Docket Item # 6
BAR CASE # 2010-0268

BAR Meeting
October 6, 2010

ISSUE: New Construction

LOCATION: 1126-1128 Prince Street

Figure 1. Plat showing proposed building and site improvements.

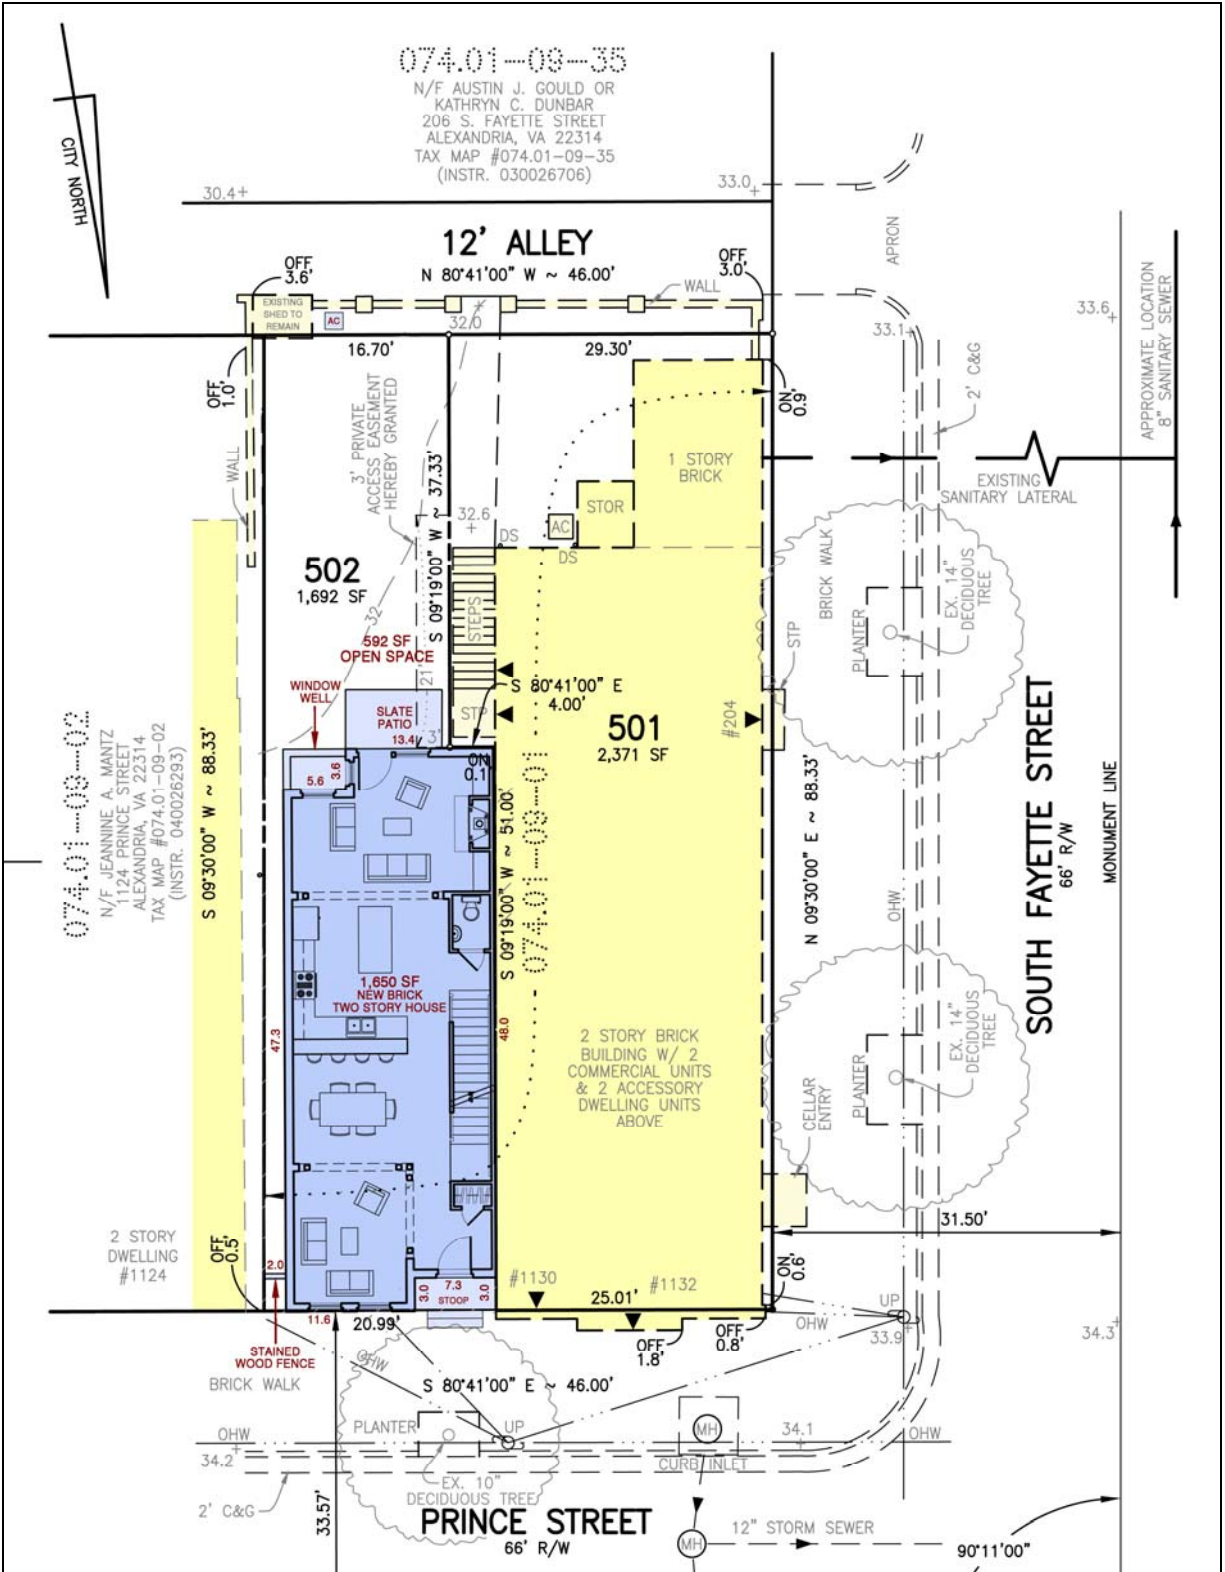
The proposed project complies with Zoning Ordinance requirements with the exception of the location of the AC condenser unit which must be relocated onto the subject property. The Director of Planning and Zoning has waived the parking requirement for this property, finding that the BAR's condition that the existing brick wall and outbuilding be preserved precludes vehicular access from the alley to the property. Any future alterations to the existing brick wall and icehouse may require an encroachment as they are located in the public right-of-way.

Staff supports many of the site improvements, including the addition of a wood gate at the easternmost section of the front elevation. The existing overhead wires and meters are on the front elevation. The applicant has confirmed that the existing overhead wires will be relocated underground and that the utility meters will be moved to the side elevation. The AC condenser unit must be relocated onto the subject property.

2. That the applicant locate the AC condenser unit on the subject property.
3. That the applicant work with staff to revise the front dormer design to make it more compatible with the architectural style of the building.

Figure 3. Proposed front (north) elevation.

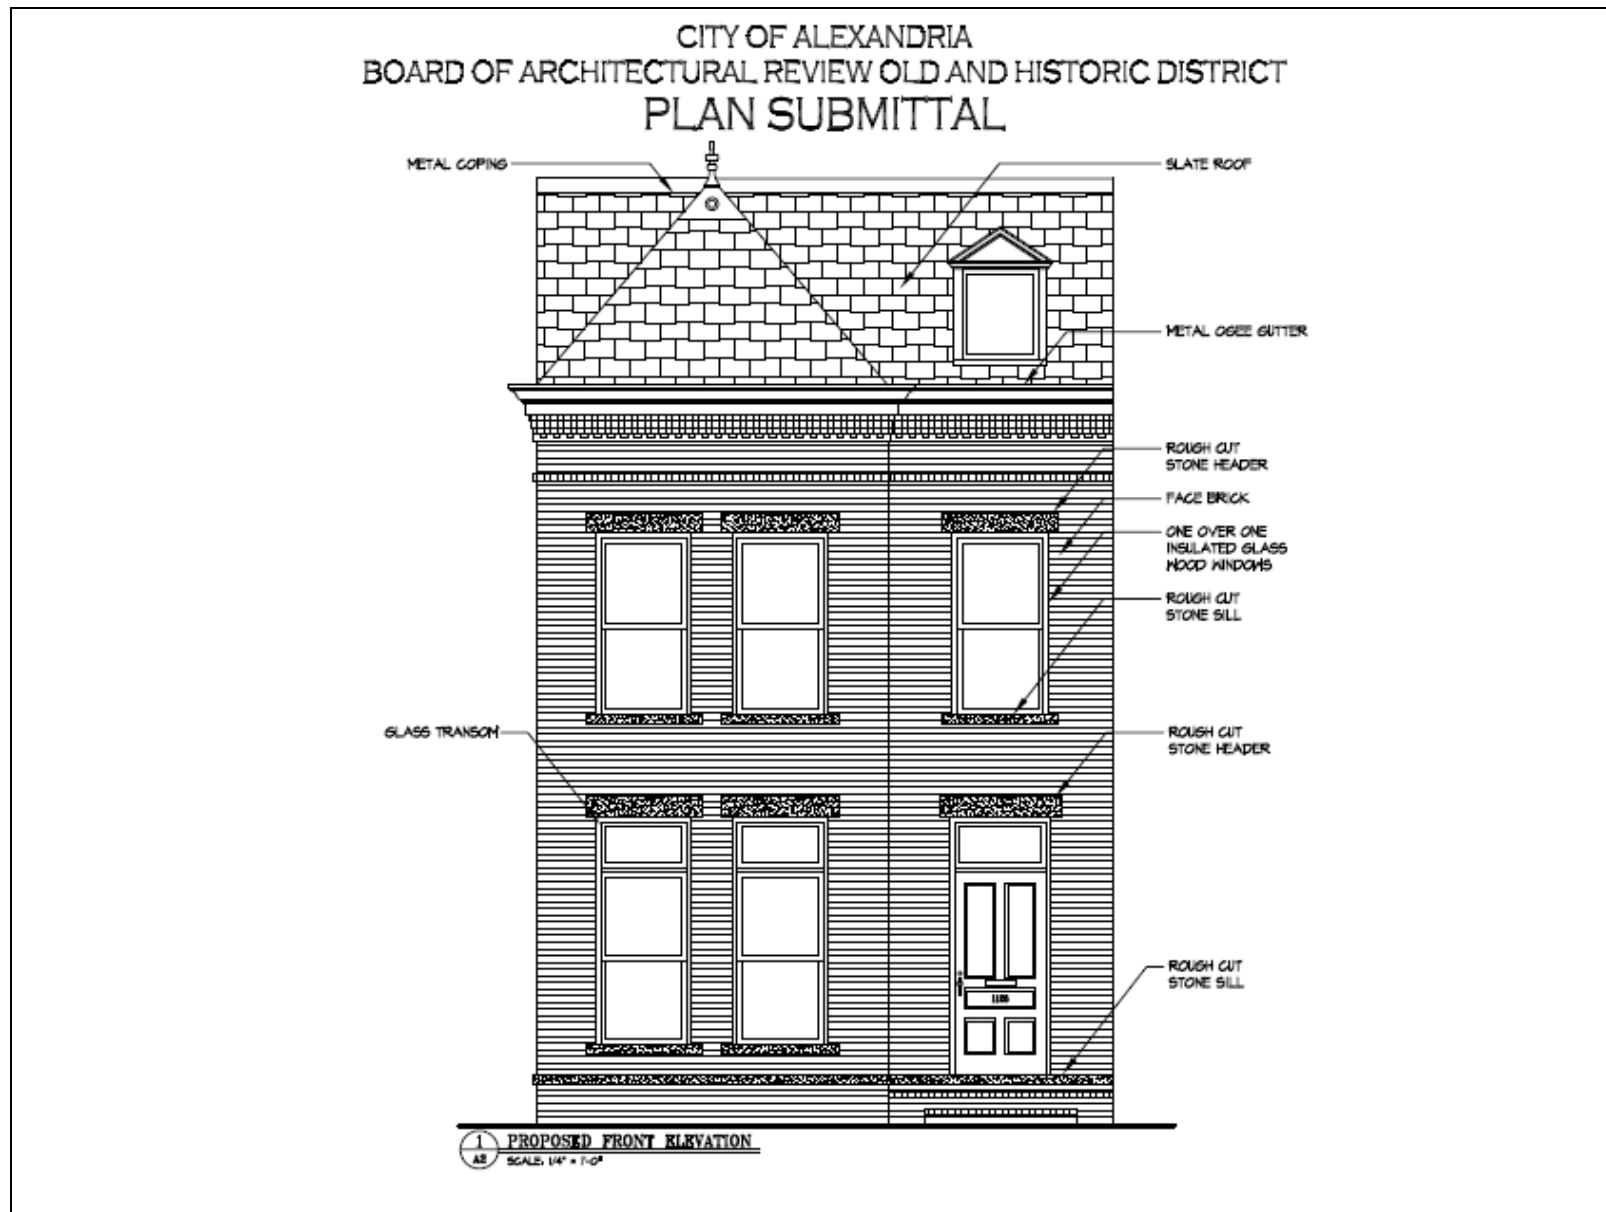
Staff finds that a dormer at the roof is an appropriate feature but notes that the proposed dormer should be revised. Historically, a single dormer on a late Victorian building would have been a special feature, an item of note. It may have had margin glass or detailed trimwork. While this is new construction and should not be a historic replication, it is an opportunity to add an element of interest or distinctiveness. Staff finds the current dormer should be refined to be more distinctive and stylistically appropriate, and less Colonial Revival in nature.

Figure 4. Proposed side (west and east) and rear (south) elevations.

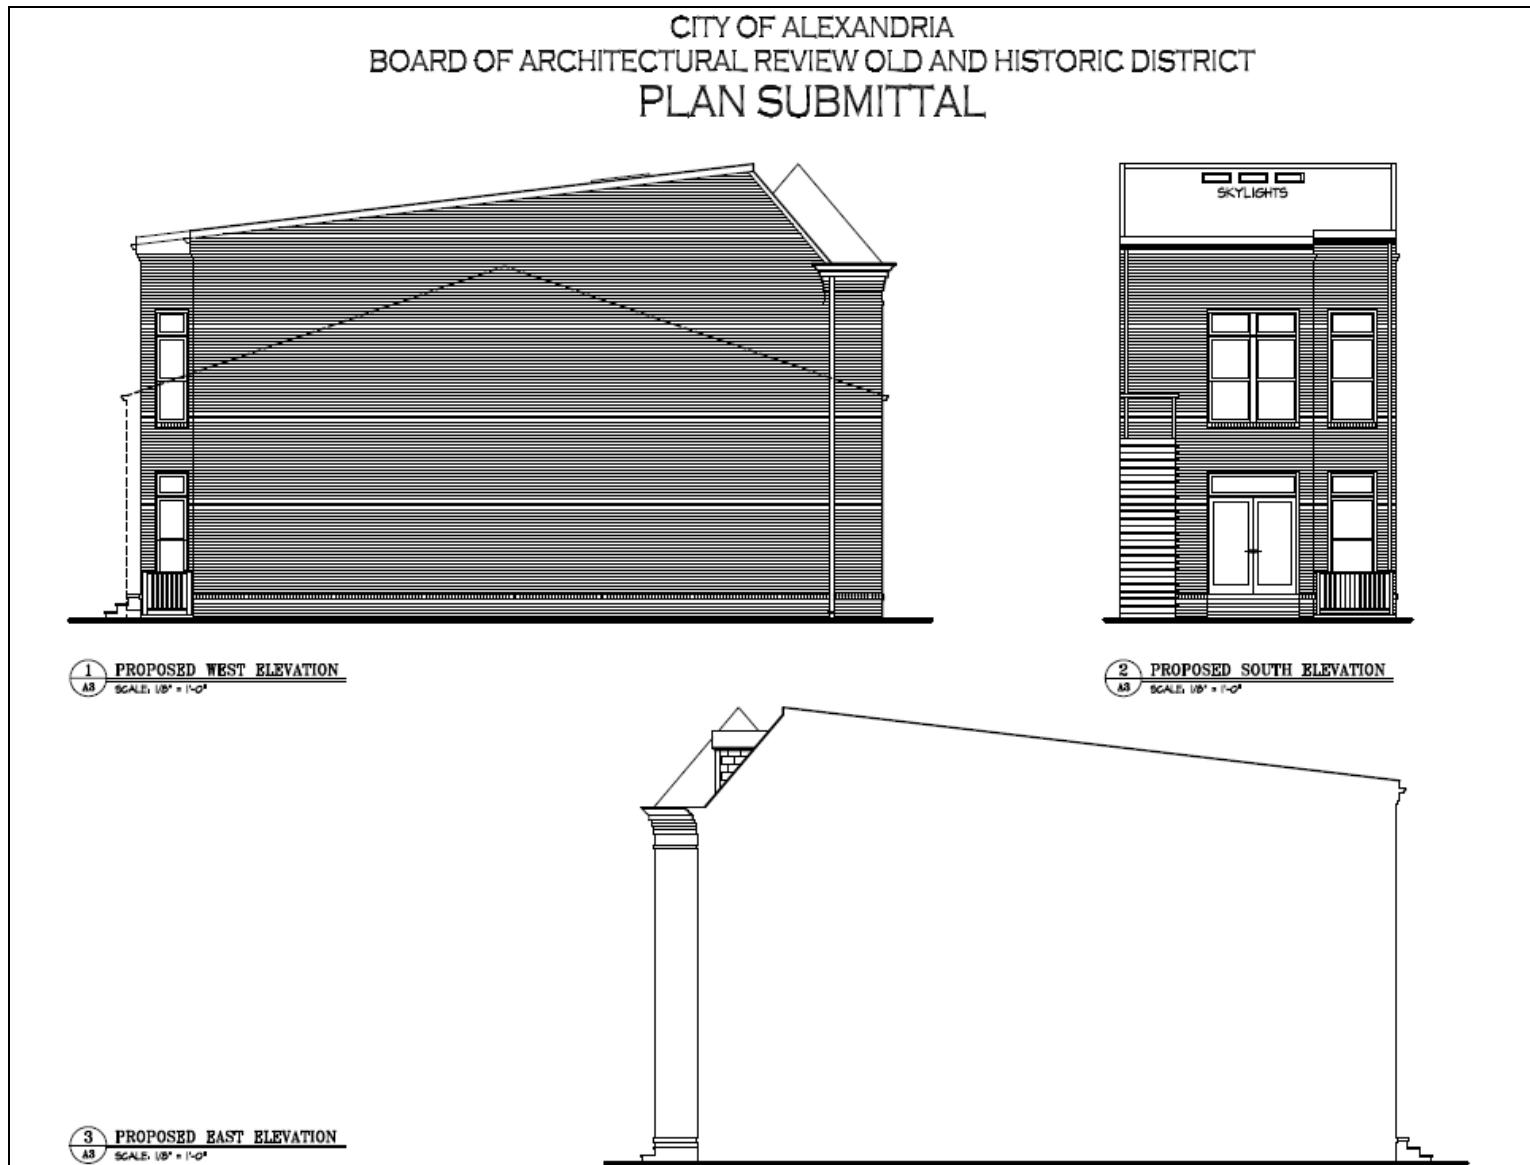
The rear elevation of the townhouse will be visible from South Fayette Street. While the rear elevation does not have many characteristic late Victorian details, it is similar to the rear elevations of countless buildings throughout the district that have been altered or had rear additions. Staff recommends that a soldier course brick header be added over the windows and doors on the rear elevation. The fire escape stairs that are shown are located on the corner parcel, 1130-1132 Prince Street. The applicant is proposing a shed roof on the rear portion with skylights which will not be visible. Staff recommends that a light-colored roof be used on the rear slope to minimize the urban heat island effect in support of the City's Green Building program.

4. That a soldier course header be added above the doors and windows on the rear elevation.
5. That the following archaeology conditions appear in the General Notes of all site plans and on all site plan sheets that involve demolition or ground disturbance (including Basement/Foundation Plans, Demolition, Erosion and Sediment Control, Grading, Landscaping, Utilities, and Sheeting and Shoring) so that on-site contractors are aware of the requirements.
